## Application to Change a Development Approval for Stage 2B of Ascot Green (Council Ref: A006490462)

In accordance with Section 78 of the *Planning Act 2016* ('Planning Act') and on behalf of *Mirvac Queensland Pty Ltd* (the 'Applicant'), we hereby make a request to Brisbane City Council ('Council') to change an existing development approval for a Development Permit for Material Change of Use for Multiple Dwelling and Development Permit for Carrying out Building Work on a Heritage Place at 230 & 260 Lancaster Road, 128 Nudgee Road, 21 St Leger Way and over Common Property (Lot 0 on SP283535 and Lot 0 on SP326606), Ascot ('the site'). The site is more formally described as Lot 2 on SP326604, Lot 0 on SP326606, and parts of Lot 801 on SP292903, Lot 807 on SP303572, Lot 13 on SP122231 and Lot 0 on SP283535).

**Figure 1 – Proposed Unit Amalgamations**

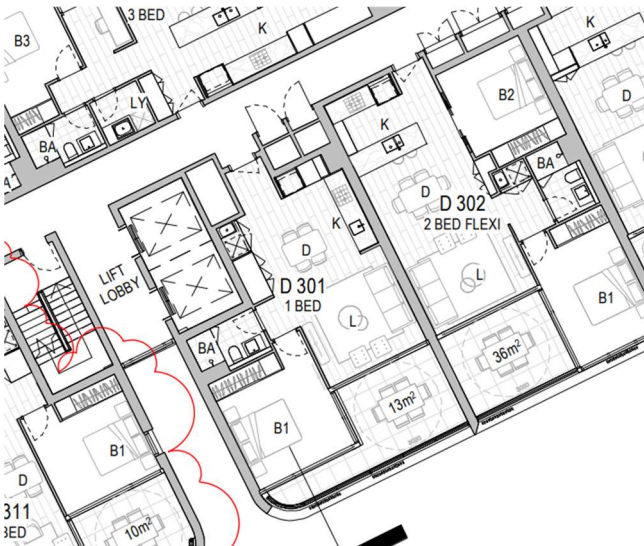
A limited number of 1-2 bedroom units are proposed to be amalgamated to create south facing 3-bedroom apartments to enhance and diversify the previous approved product mix (refer to **Figure 1**). As a result of the amalgamations, the total number of units across Tower D (Stage 2B) will be reduced from 126 units to 117 units. **Table 2** provides a comparison of the approved and proposed unit breakdown for Tower D.

In addition to the unit amalgamations, minor internal configurations of the apartments are proposed in response to market demand and detailed design. These internal layout changes are maintained within the existing approved building envelope and in some instances result in only very minor changes to externally-facing windows and balconies.

**Figure 2 – Proposed Façade Amendments**

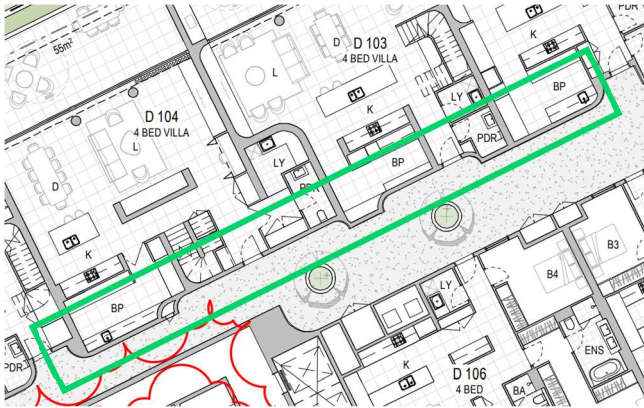
- **Bedroom Façade Realignment:** The bedroom façade of the Types 1 and 5 units on Level 2 will be extended to align with the façade lines above, to create a more uniform building line. Whilst the proposed extension encroaches within the balcony, the balcony maintains an area in excess of the minimum required dimensions and continues to provide a functional space (refer to **Pictures 7-8**).

- **Villa Unit Window Removal:** As part of the proposed amendments, windows to the butler's pantry and robe areas of the 'villa' units will be removed to address privacy concerns. Under the current approval, these windows face the laneway, allowing direct views from passers-by (refer to **Pictures 9-10**).

**Figure 4 – Rooftop Amendments**

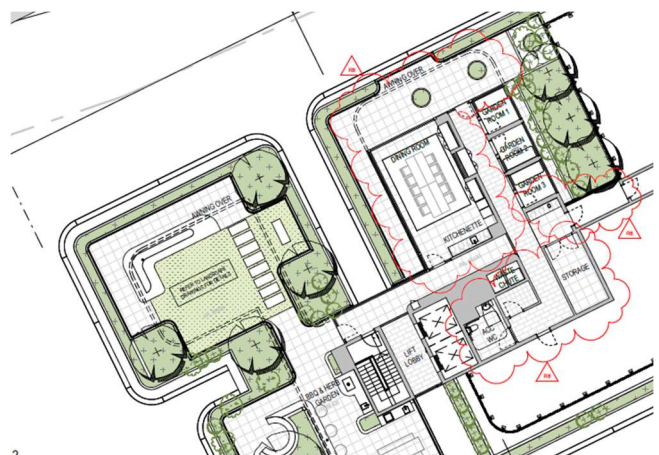
- Reconfigure the existing approved boardroom into a dining room that incorporates a more functional kitchenette (refer to **Figure 4**). The kitchenette will be modest in scale.

- Amend the location of the storage and accessible toilet through internal layout changes to improve overall usability.
- Remove pavers from the fire escape to the east of the garden rooms to improve safety.
- Realign shade structures to maximise construction efficiencies, usability and maintenance.

**Figure 5 – Proposed Removal of Walkway (East) (Emphasis in Green)**

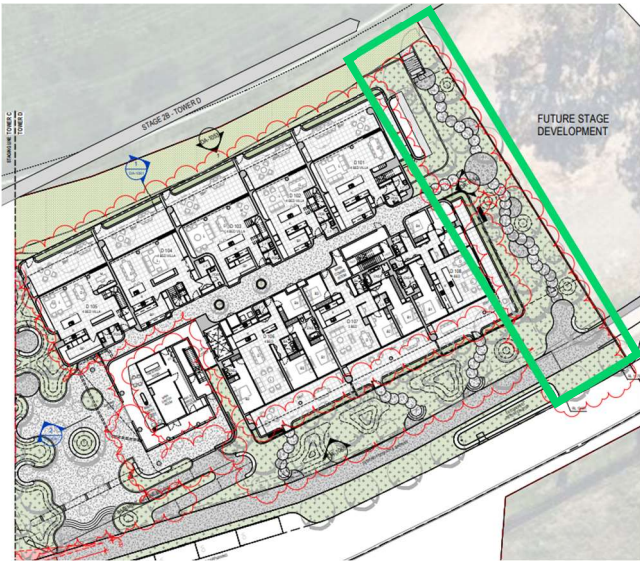
### 3.5 Ground Plane and Public Realm

**Figure 6 – Proposed Removal of Raised Planters and Seating Nook Planters (Emphasis in Green)**

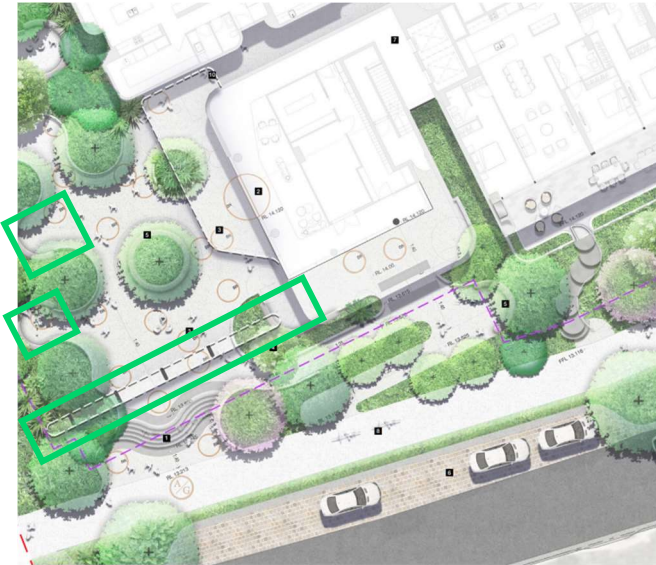
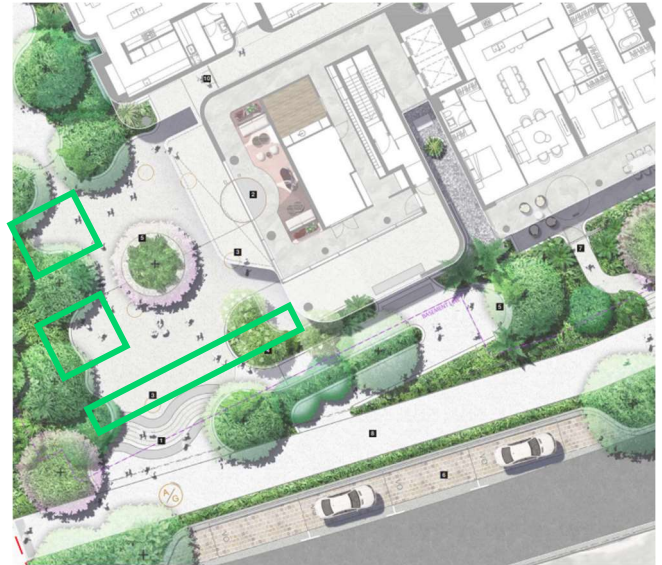
- **Raised planter amendments:** The raised planter cover over the western pedestrian entrance is proposed to be removed. This change will improve circulation in the arrival area and enhance the legibility of the entrance. It's removal also ensures that all landscaping can be maintained to a high standard, with the structure posing issues in terms of accessibility and practicality of maintenance. Notwithstanding the proposed removal of the planters, generous landscaping treatments are provided across the development at the ground plane and through the built form Refer to **Pictures 25-26**).

- **Seating nook planters:** Two seating nooks within the planters are proposed to be removed to enhance construction efficiencies. Specifically, landscaping and seating nooks are rearranged to eliminate planters straddling across construction joints, resulting in an outcome that complies with more current waterproofing philosophies. Monitoring of the constructed Tower C (Stage 2A) also indicates these spaces are not actively used by residents. As such, general realignment of the planters and the retention of a single seating nook is considered sufficient to meet amenity needs without compromising constructability (Refer to **Pictures 25-26**).
